**PETITION NO. 1120** – The United Illuminating Company petition for a declaratory ruling that no Certificate of Environmental Compatibility and Public Need is required for the proposed modifications to the Hawthorne Substation located at 180 Hawthorne Drive, Fairfield, Connecticut.

**PETITION NO. 1120 - The United Illuminating Company petition for a declaratory ruling that no Certificate of Environmental Compatibility and Public Need are required for the proposed modifications to the Hawthorne Substation located at 180 Hawthorne Drive, Fairfield, CT, 06825.**

**If, in fact, The CSC is not given sufficient reason to deny the application, the Concerned Citizens of North Stratfield (CCNS) request that the CSC propose this Development and Management plan to UI for both the existing substation and the proposed modifications to the existing substation.**

**OPTION 1**

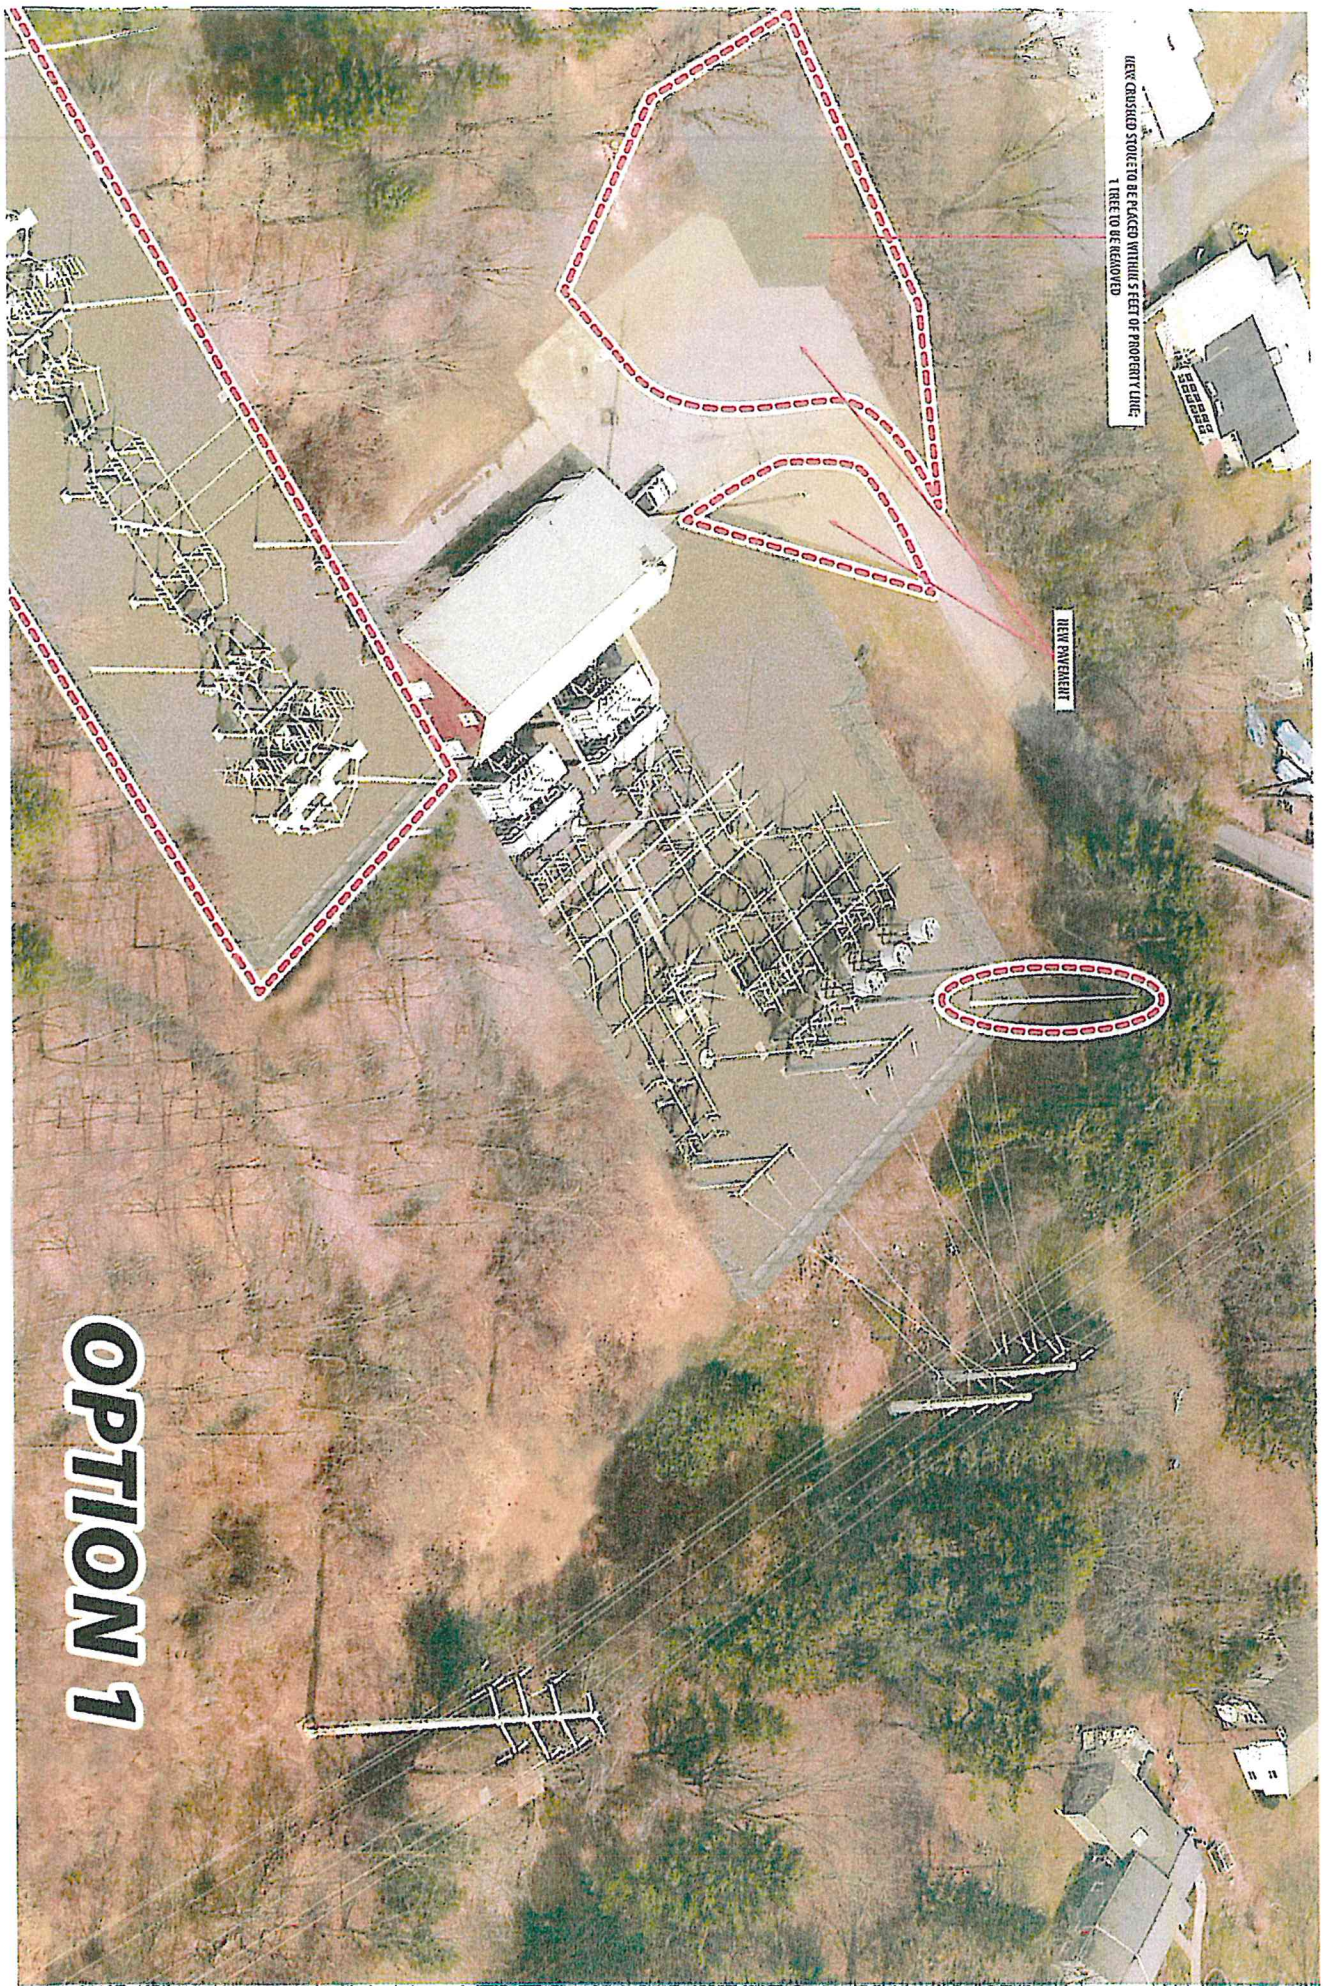
1. UI shall review and address the possibility of repositioning the new modifications more to the north, further away from the abutting properties on Schiller Road and Hawthorne Drive. Please see attachments 1 and 2.
